Subject: Response to the FCC Correspondence Reference # 31231 for additional information on RIM BlackBerry Wireless Handheld FCC ID: L6ARAR20CN, 731 Confirmation # EA300691.

The following addresses the comment on your **Correspondence Reference # 31231**, dated July 26, 2006.

Input level measurement analyzer plots for the sinusoidal 1.025 kHz signal

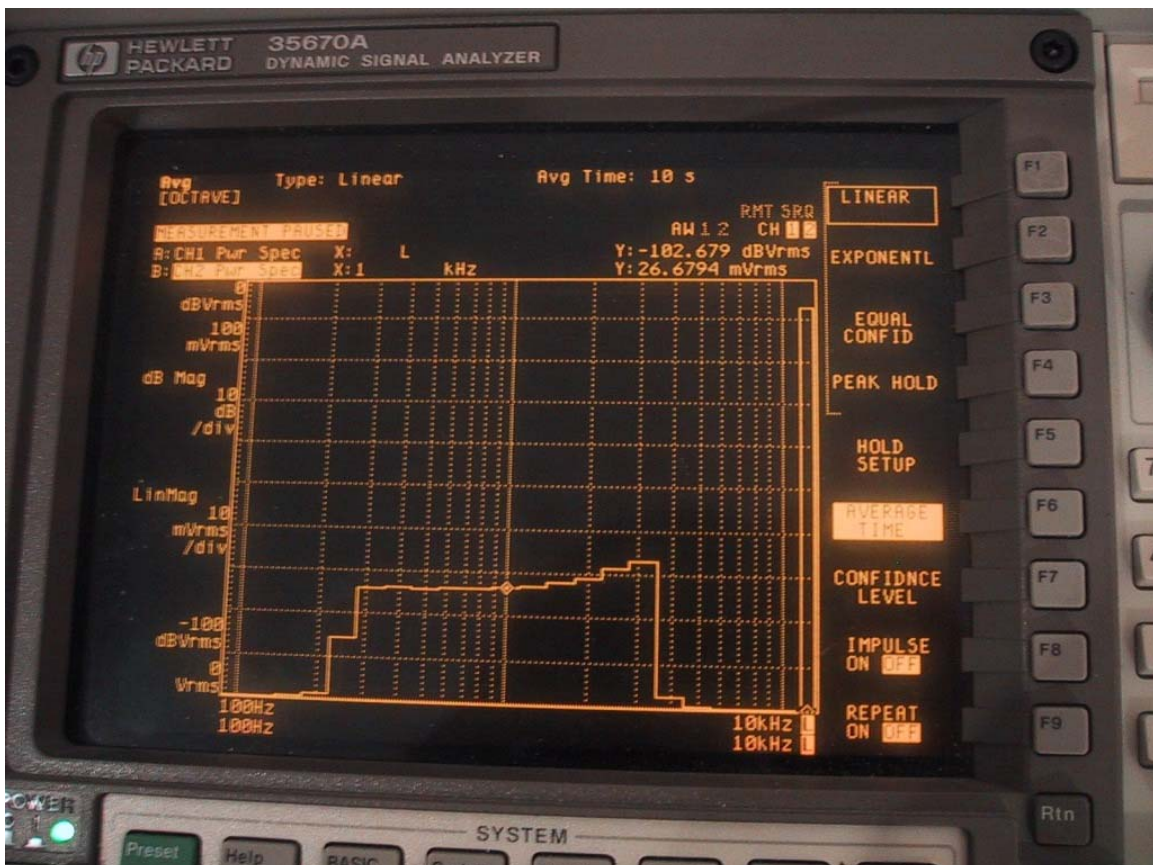
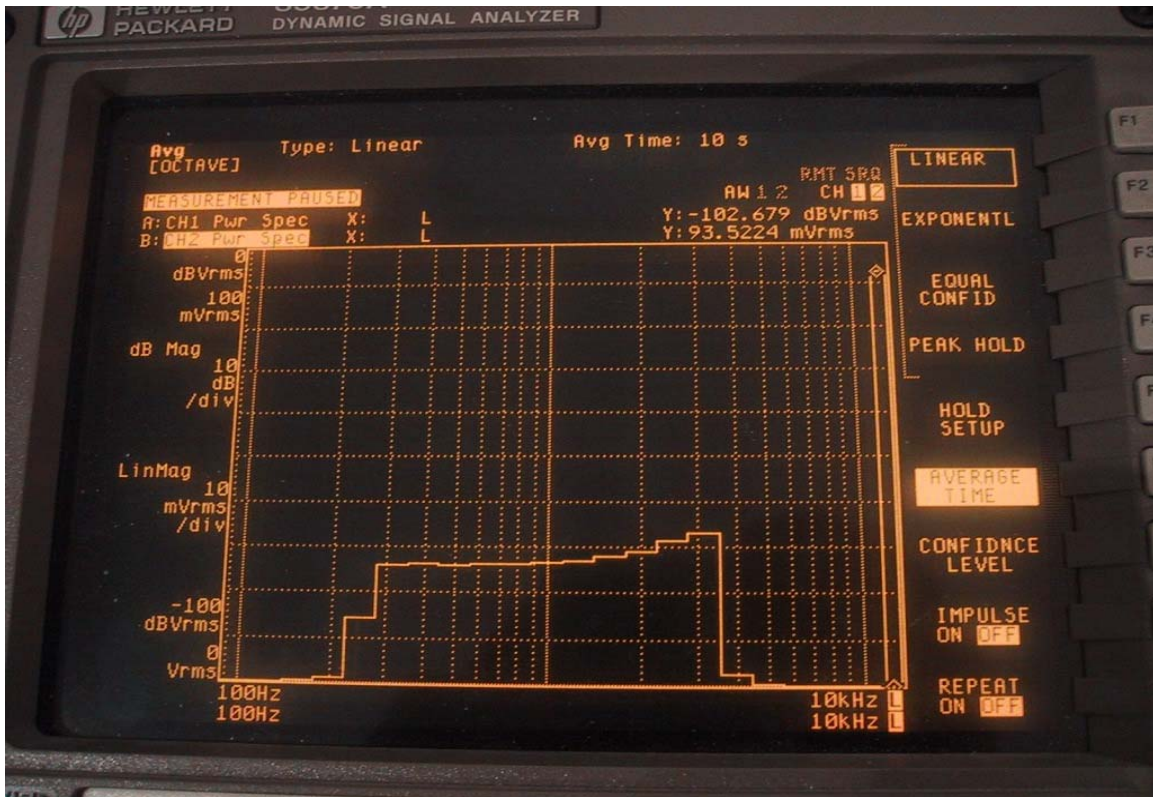
A) Regarding your answer to question 1 Please update the report to list file lengths, averaging times and any other measurement specific related information such as BWC for all measurements. Please include measurement of the input reference level. Please also specify averaging times for ABM2. Related textual explanations should be comprehensive and clear. FYI Please note that integration times for the measurement should typically be equal to that used for the reference level measurement.

Time averaging was used with an artificial speech based signal when setting the input reference level. The averaging period was adequate to cover the signal period and the averaging method was the same for setting the reference level and performing the measurement.

A Dynamic Signal Analyzer was used to measure the time averaging of the speech-simulated signal. The analyzer was set to measure the audio signal at 1/3 octave with 10 seconds time averaging. The speech simulated signal duration is 2 seconds and the sinusoidal signal duration is 10 seconds. The DASY4 program was set to repeat the audio file while performing time averaging.

"L" shows power sum

The following are ABM2 measurement data and plots for supported speech service options, vocoder type and RF channel to show justification:

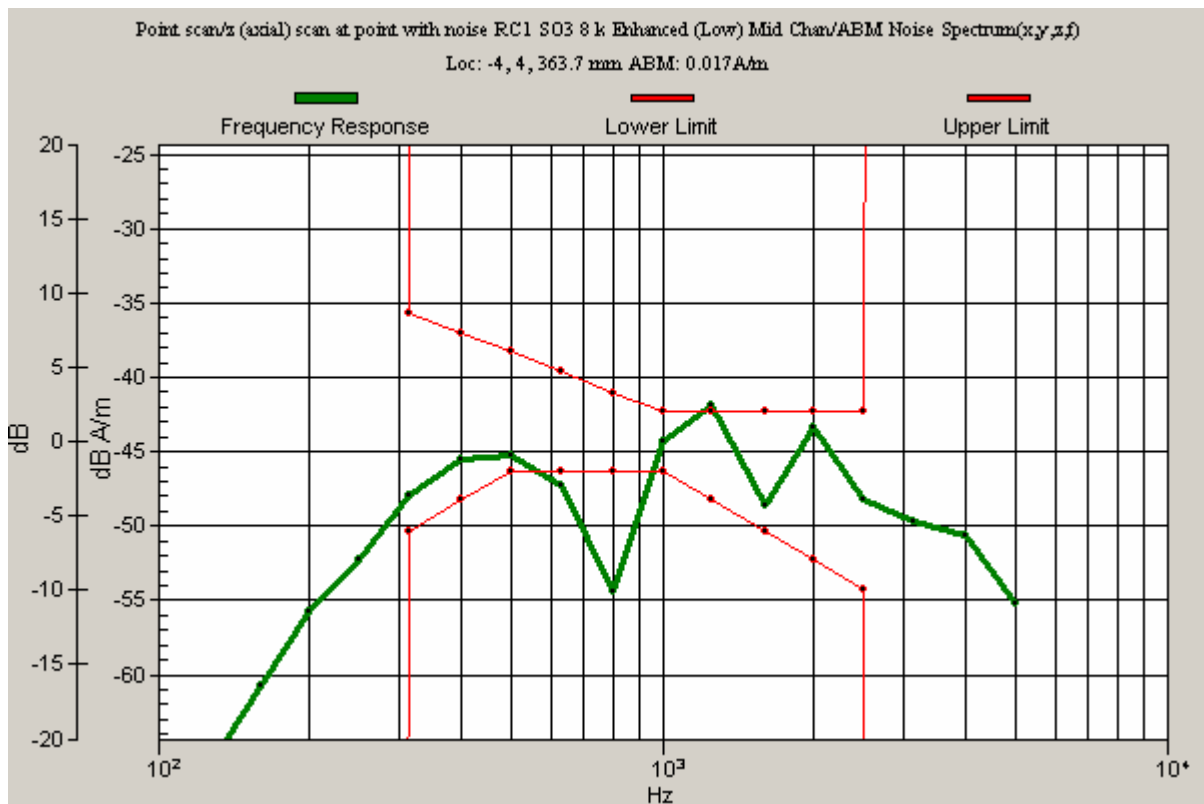
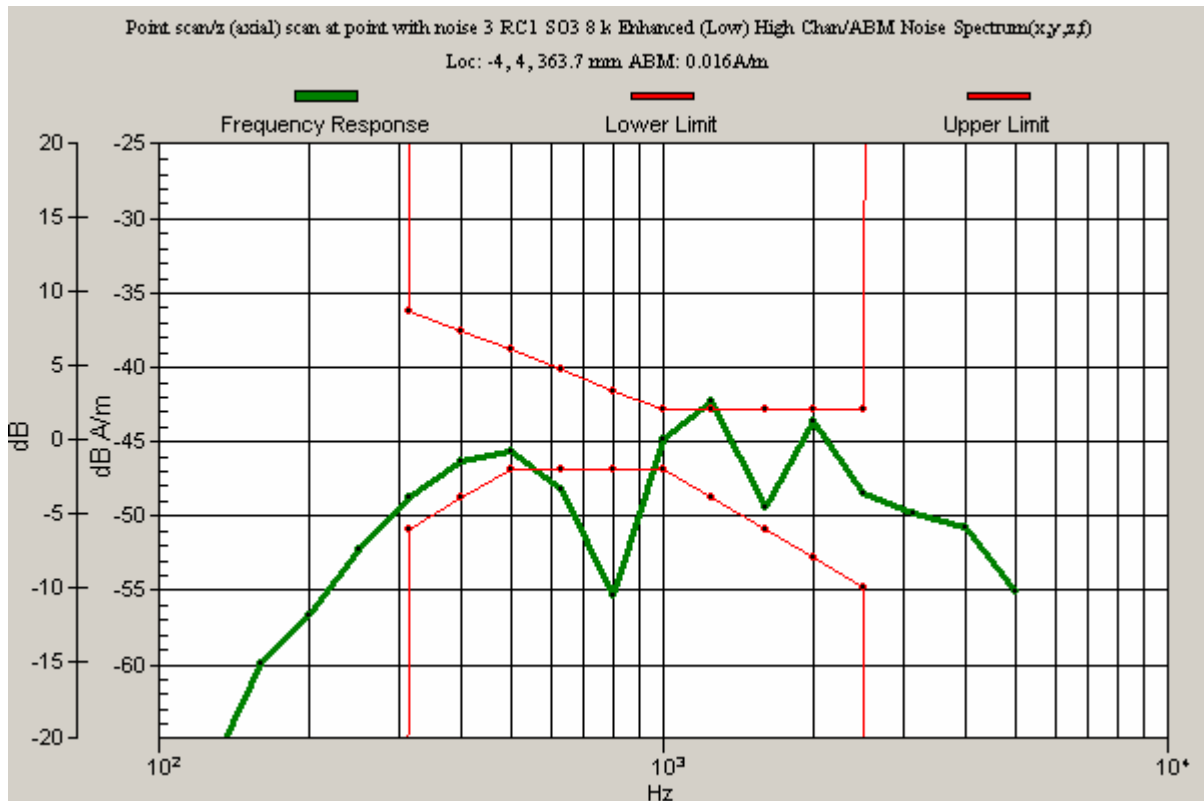
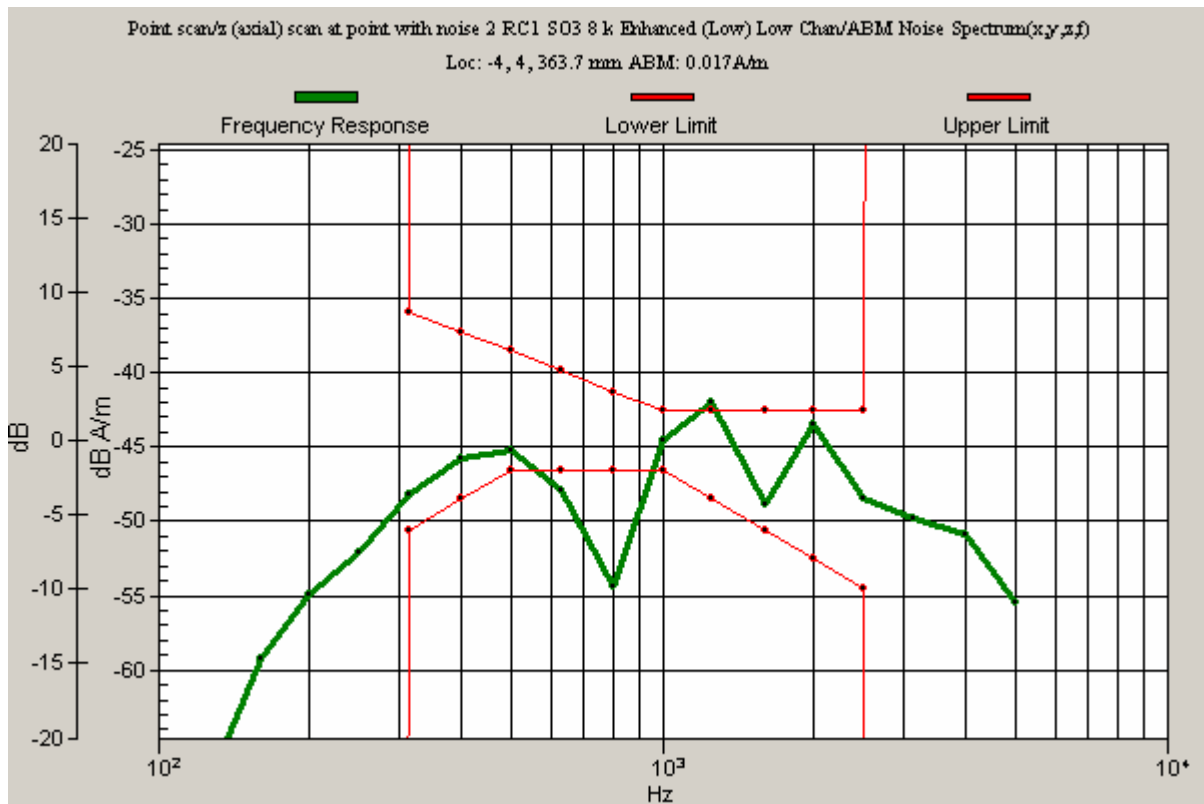
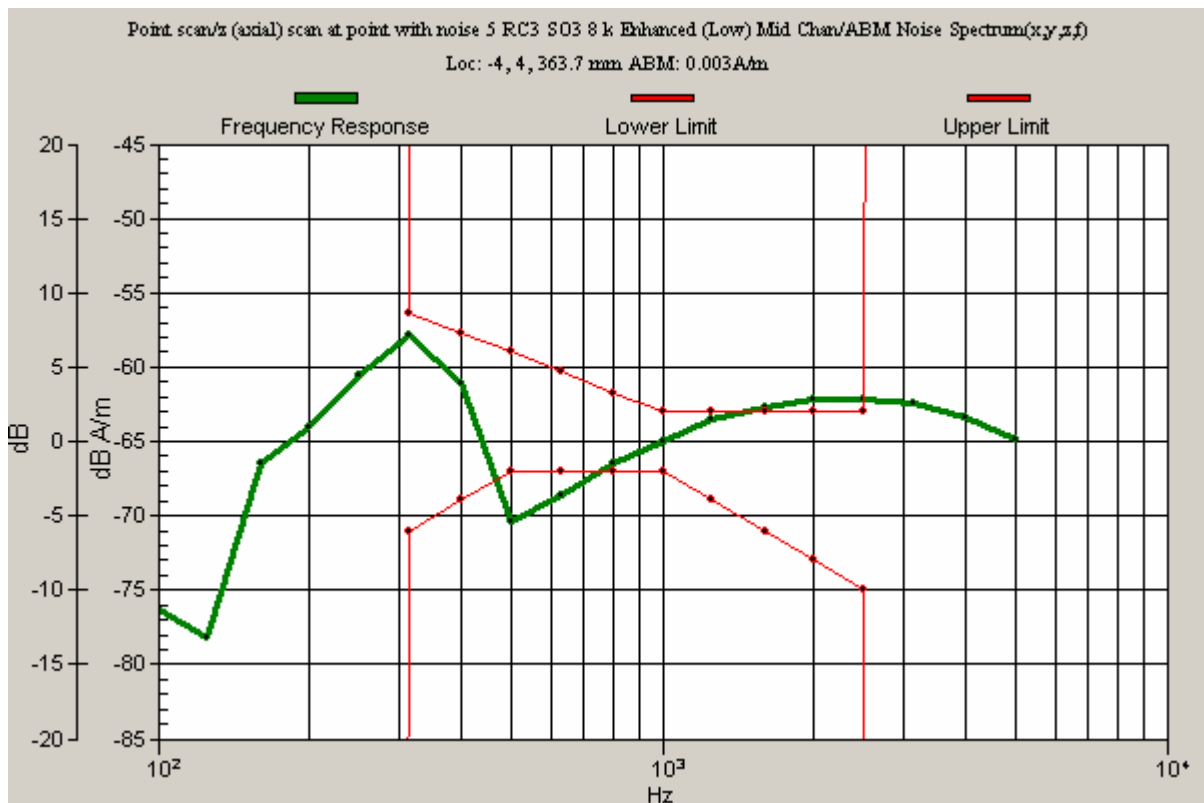
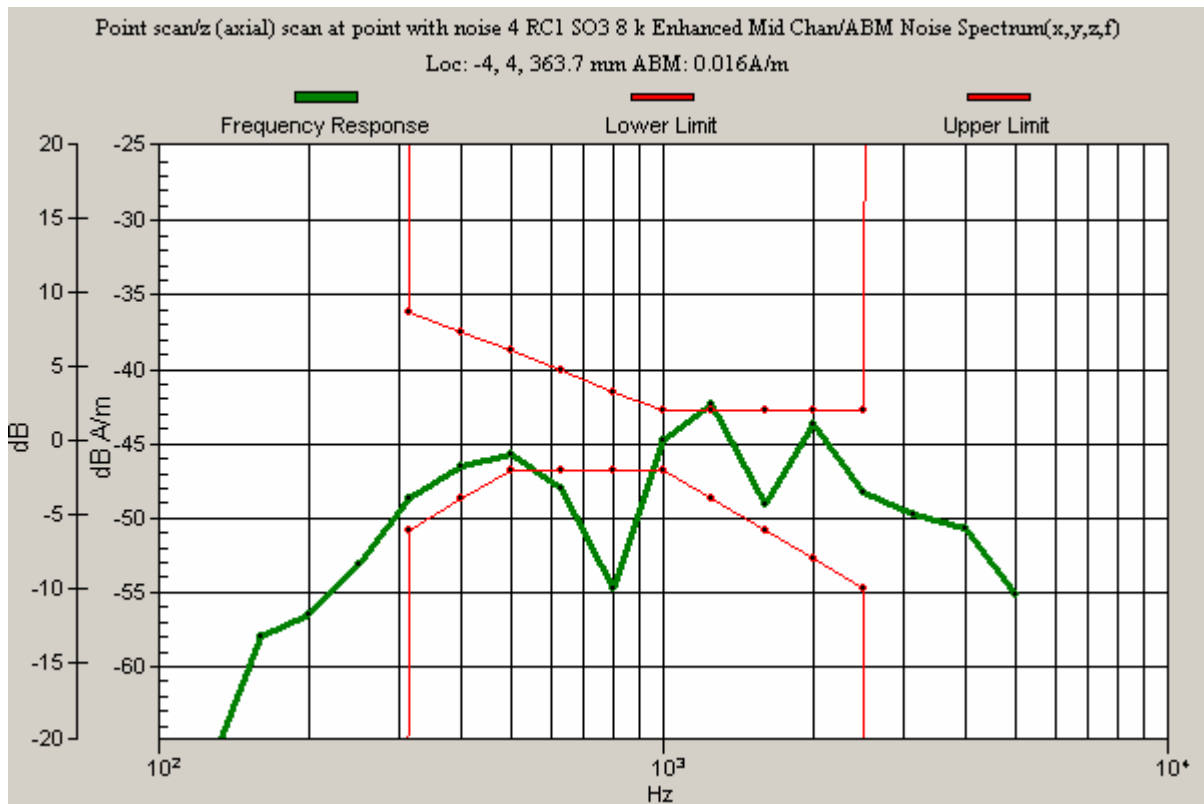
C) Regarding your answer to question 3. Please readdress. The procedure mentioned pertains to SAR testing not HAC. Please justify the subset tested in accordance with the FCC 3G procedure for HAC. Also, you mentioned that the device has both 8K enhanced and 8K enhanced low. Please address both or justify subset testing.

These were evaluated and the worst case ABM2 was determined to be RC1, SO3 and 8k Enhanced (Low), mid channel.
In addition, the RF environment (M rating) for T-Coil rating was determined by evaluating 1/8 th rate RC1, SO2 option. This option does not have a vocoder to perform ABM measurements.
